**CITY OF HANOVER
PLANNING COMMISSION MEETING
MAY 22, 2017**

Date: May 22, 2017
To: Planning Commission
From: Cindy Nash, City Planner
RE: Public Works Building – Amended Site Plan

HANOVER PUBLIC WORKS FACILITY

SITE IMPROVEMENT PROJECT

Site Plan

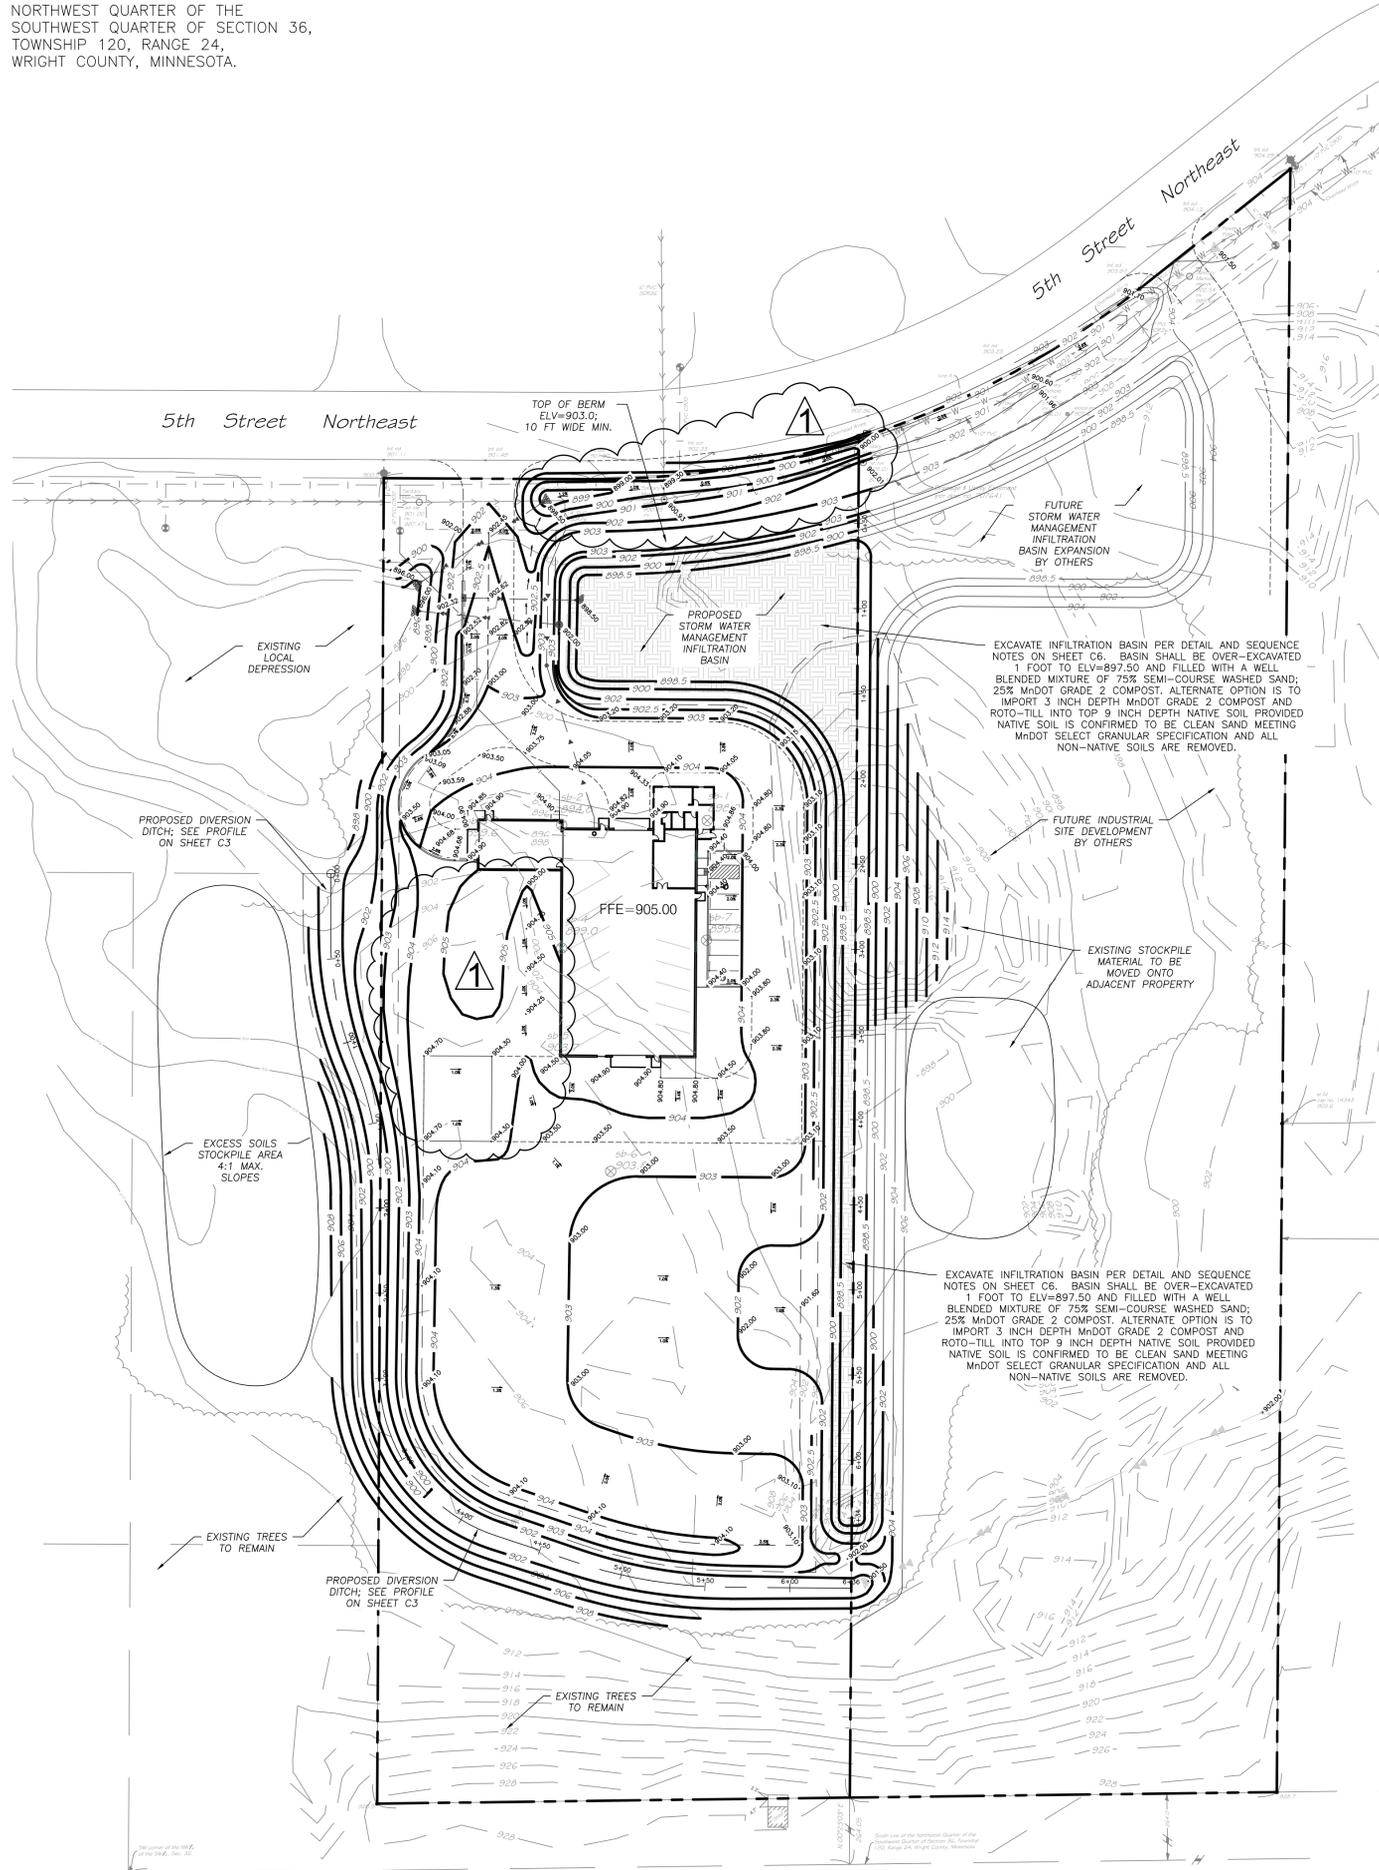
1. Salt shed was relocated to the south and shown on proposed heavy duty pavement.
2. Grading on the west side of the building was modified with minimal surface drainage profile slope to direct runoff south across pavement and into open storage are such that it would ultimately route to the storm water basin.
3. Storm sewer has been removed from the 5th Street roadside ditch. Proposed ditch grading is minimal in depth and minimal profile shape.
4. Culvert is indicated under the access driveway to accommodate drainage of 5th Street roadside ditch.
5. Storm water basin overflow outlet structure and pipe have been relocated to the west side of the basin with pipe extending under the access drive.
6. Water service extension into the building was revised to utility room within truck wash space.

1. Development of the site must be in substantial conformance with the plans prepared by Civil Engineering Site Design and last revised on May 10, 2017. If any additional minor revisions are proposed to the site plans, they may be approved administratively by staff.
